ELEVATOR DEFLECTION STOP UPDATE: MARCH 2008

| <p>MODEL NO. ZODIAC CH 601</p> | <p>DESCRIPTION: ELEVATOR DEFLECTION LIMITS</p> <p>COPYRIGHT © 2008 Chris Heintz DATE: 03/08</p> | |

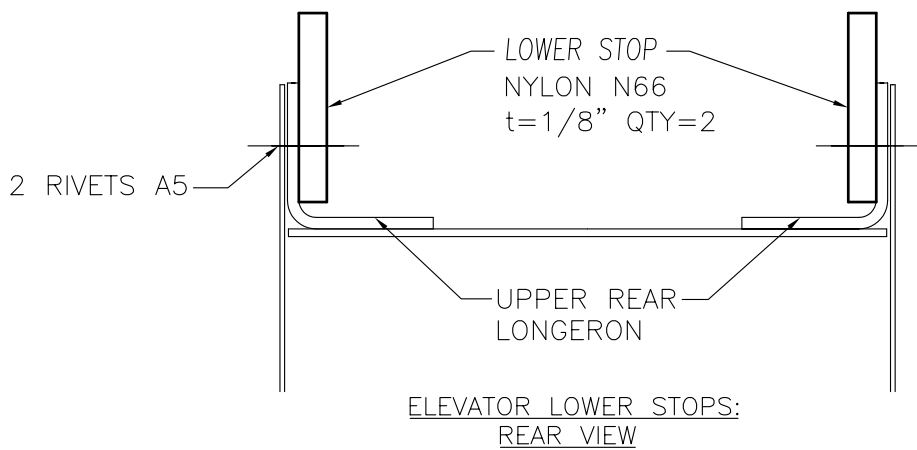
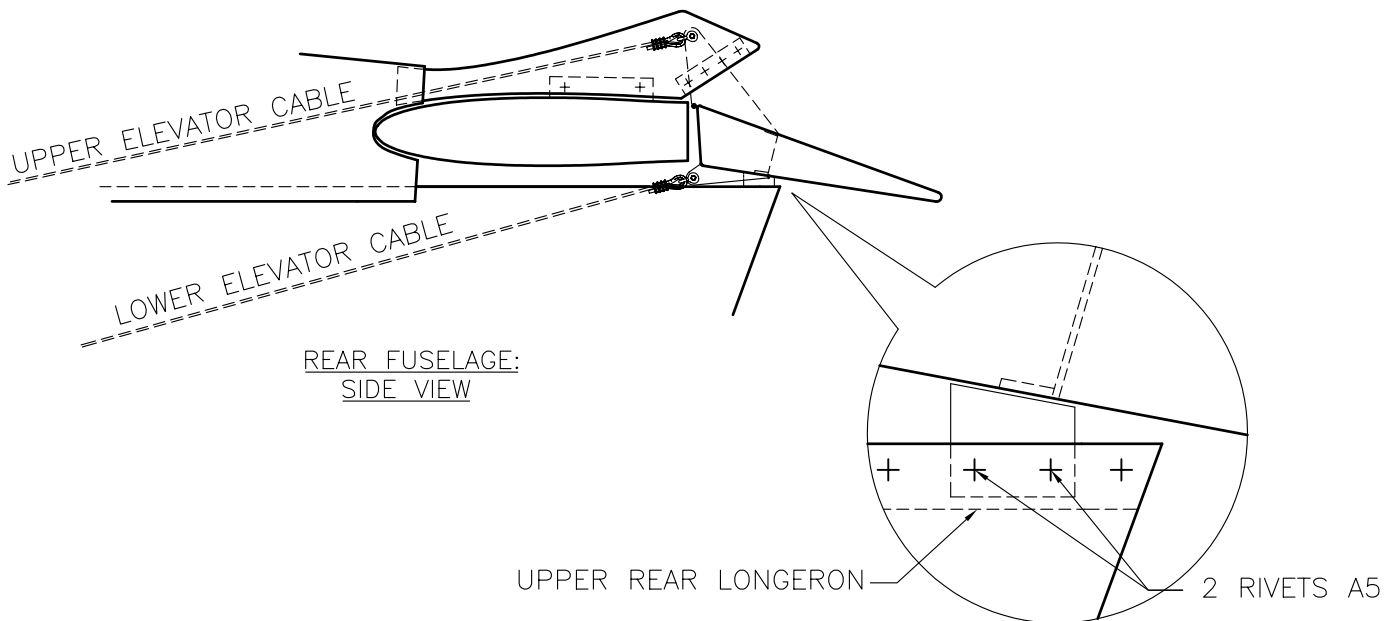
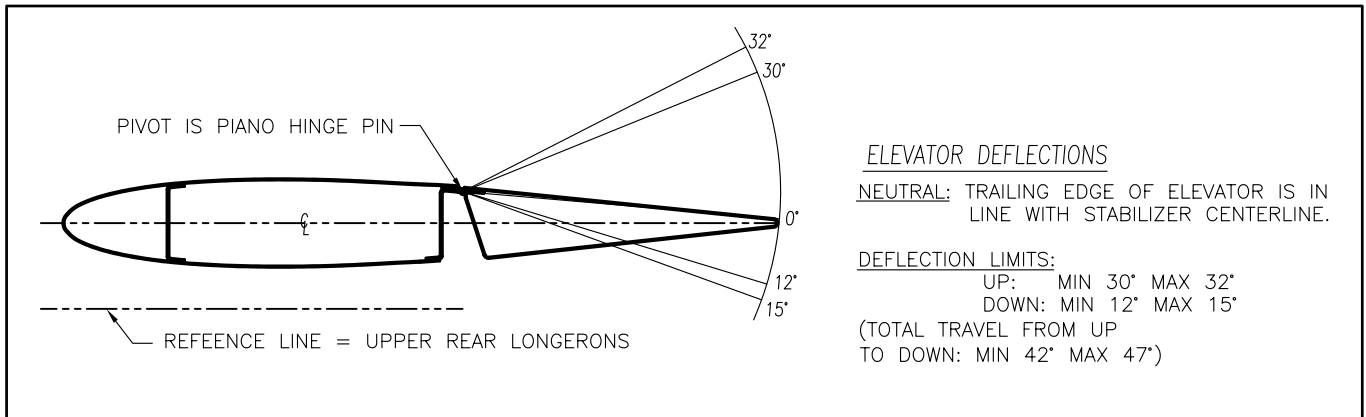
The following is an approved modification to limit elevator deflection per Chris Heintz letter dated 25 March, 2008.
